**Proposal for Amendment [3] to global technical regulation
No. 9 (Pedestrian safety)**

**Proposal of amendment to ECE/TRANS/WP.29/GRSP/2013/25,
Submitted by the expert from the European Commission and
Germany**

The text reproduced below was prepared by the experts from the European Commission and Germany to align the test requirements of UN GTR No. 9 Phase 2 with those of Amendment 2 to the UN GTR concerning the determination of the headform test points. It is based on ECE/TRANS/WP.29/GRSP/2013/25 and GRSP-54-07. The modifications to the current text of UN GTR No. 9 are marked in bold for new or strikethrough for deleted characters.

Figure 28
Flexible lower legform impactor: Test set-up for the dynamic lower legform impactor certification test (inverse test, see paragraph 8.1.3.4.)

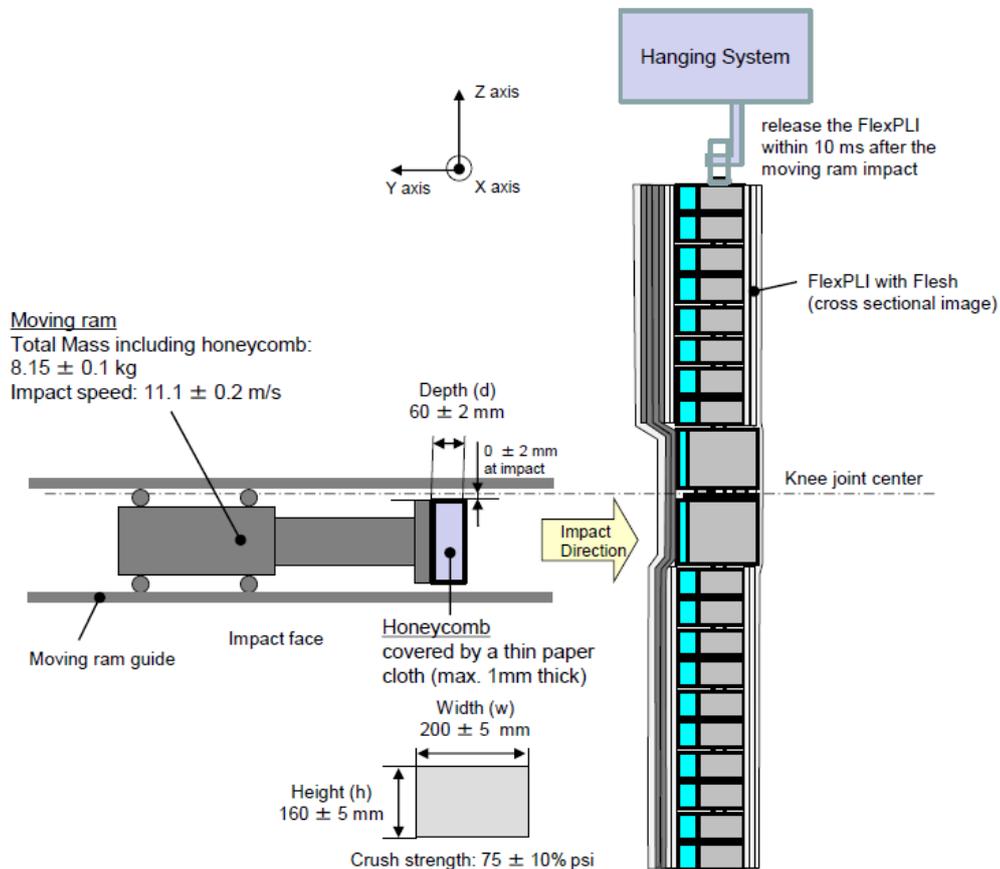
- 8.1.3.4. Test procedure**
- 8.1.3.4.1. The assembled flexible lower legform impactor (with the flesh and skin) shall be hung vertically and freely suspended from a test rig as shown in Figure 28. It is then impacted by the upper edge of a linearly guided aluminium honeycomb impactor, covered by a thin paper cloth with a maximum thickness of 1 mm, at an impact speed of 11.1 ± 0.2 m/s. The legform shall achieve a free flight condition within 10 ms after the time of first contact of the honeycomb impactor.**
